**NEW YORK POWER AUTHORITY
 JAMES A. FITZPATRICK NUCLEAR POWER PLANT
 P.O. BOX 41
 LYCOMING, NY 13093**

DOCUMENT TRANSMITTAL AND RECEIPT ACKNOWLEDGEMENT FORM

SUBJECT: **EMERGENCY PLAN AND IMPLEMENTING PROCEDURES**

DOCUMENT	PAGES	REV. #	INITIALS/DATE
EAP-1.1	REPLACE ALL	43

New York State **PART I** Form **NOTIFICATION FACT SHEET**

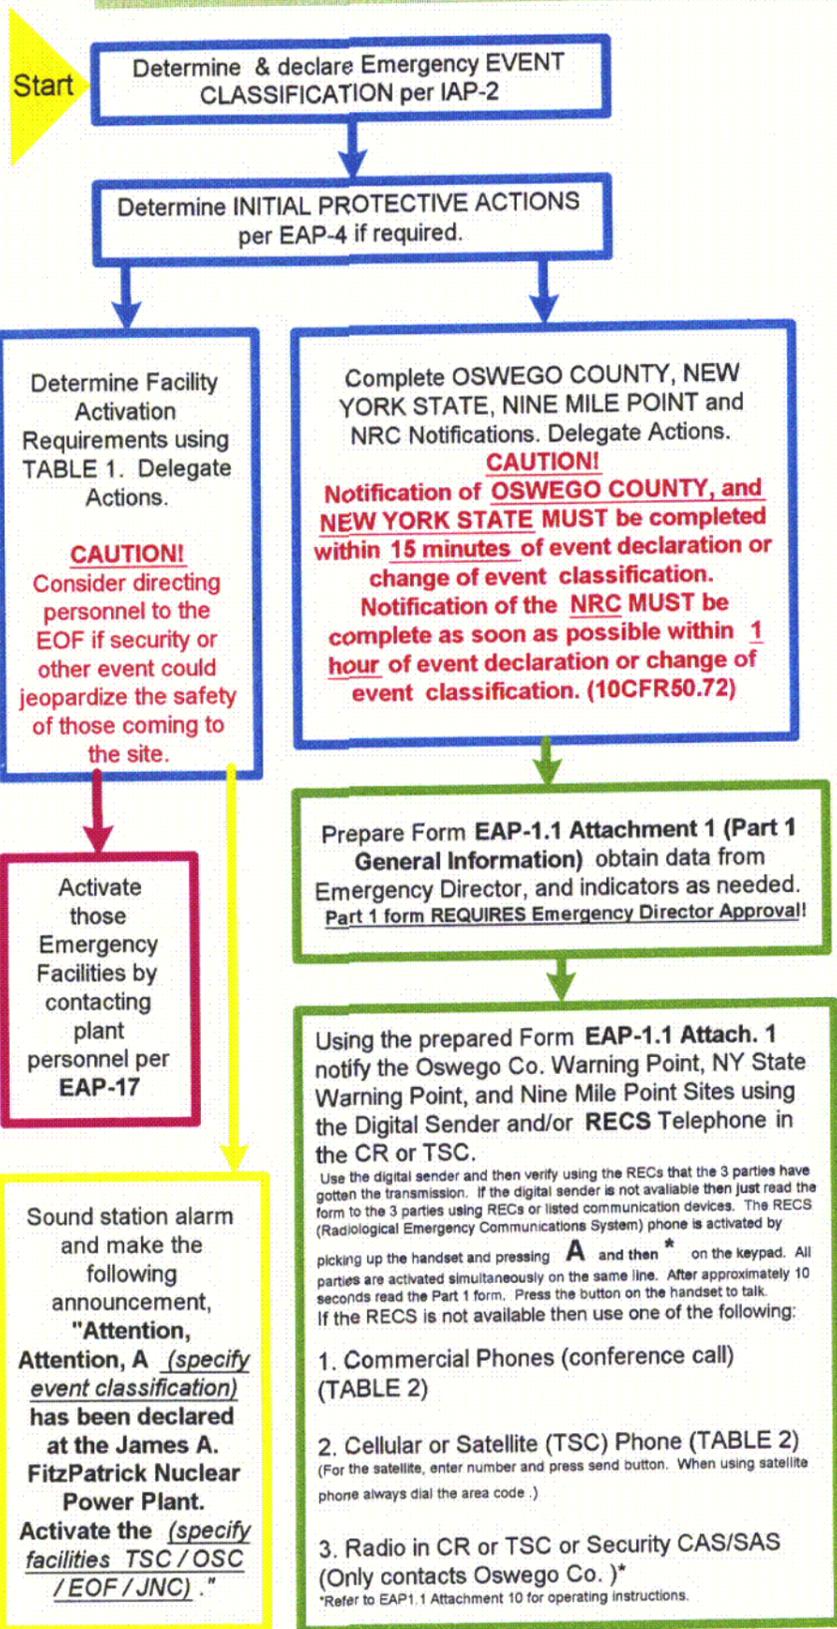
- Added Attachment 13, Part 1 General Information; partially completed,
